CITY OF ALBUQUERQUE

May 19, 2025

RE: **Lot 29 Block 1 Volcano Cliffs Unit 22 SAD 228**
8015 Canoncito Dr. NW
Grading and Drainage Plan
Engineers Stamp Date 4/1/2025 (D10D003N29)
Pad Certification Date 5/12/2025

ENGINEER'S SEAL	LOT 29 BLK 1 U 22 VC 8015 CANONCITO DRIVE NW	DRAWN BY DEM
DAVID SOULE NEW MEXICO 14522 REGISTERED PROFESSIONAL ENGINEER	GRADING AND DRAINAGE PLAN	DATE 3-30-25
4/1/25	Rio Grande Engineering	SHEET # C1
DAVID SOULE P.E. #14522	P.O. BOX 53924 ALBUQUERQUE, NM 87199 (505) 321-9099	JOB #

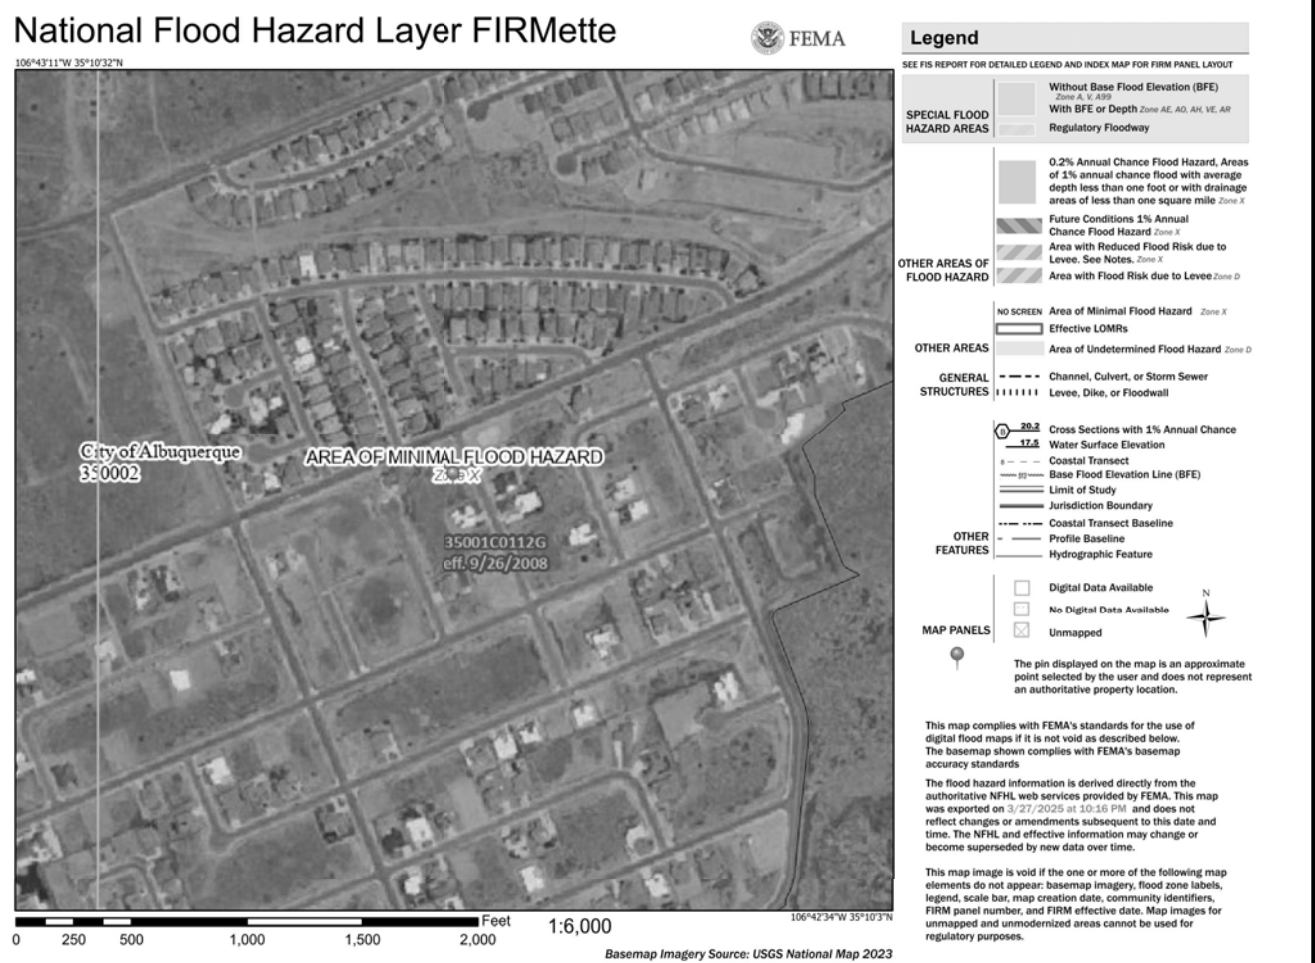
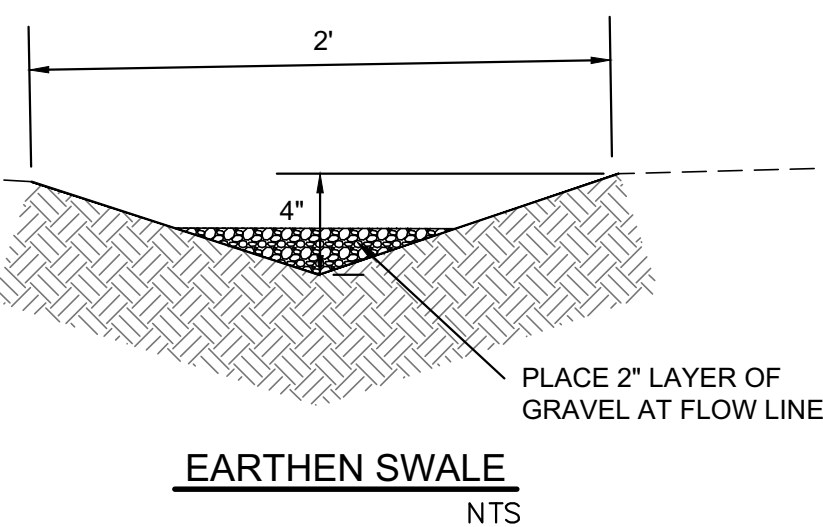
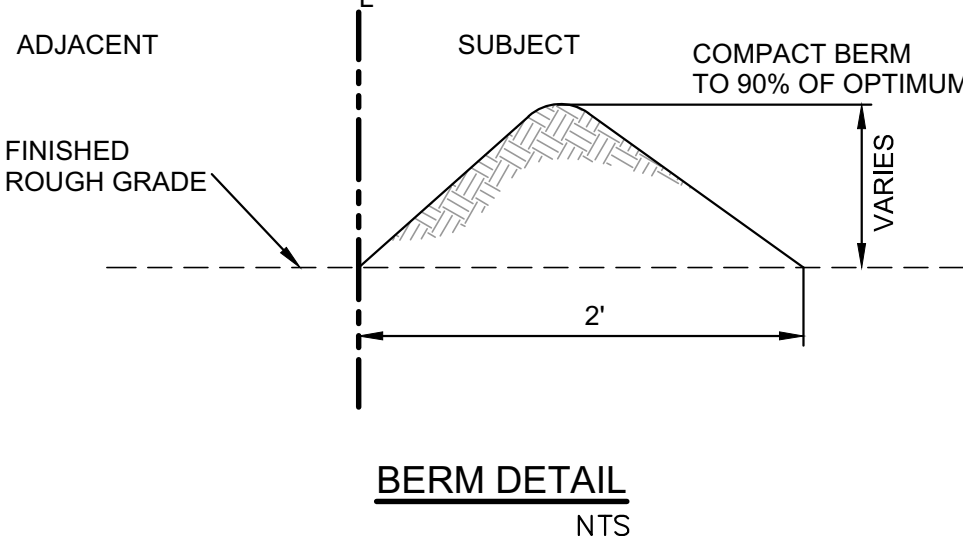
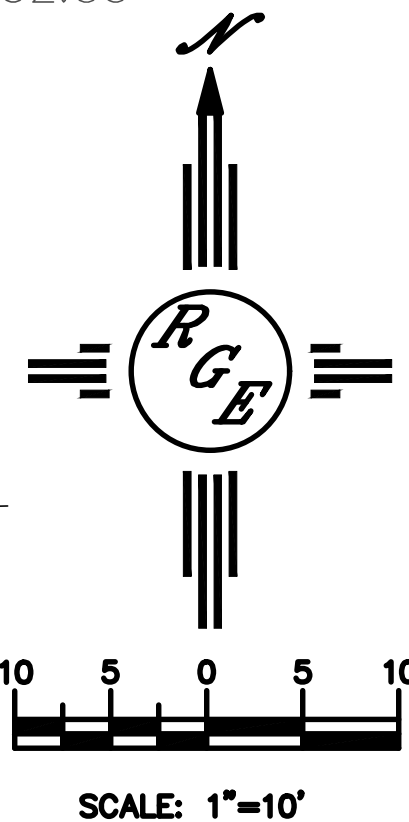
Based upon the information provided in your submittal received 5/16/2025, this plan is approved for building permit.

Please inform the builder/owner to attach a copy of this approved plan and this letter to the construction sets in the permitting process prior to sign-off by Hydrology.

Reiterate to the Owner/Contractor that a separate permit for a garden/retaining wall must be obtained, with the approved G&D plan and Pad Certification. Advise the owner & Contractor that dirt is not allowed in the public right of way to climb the curb. Crusher fines or lumber is allowed. If dirt is used this will delay going forward with the construction of the home.

Prior to Certificate of Occupancy release, Engineer Certification per the DPM checklist of this plan will be required.
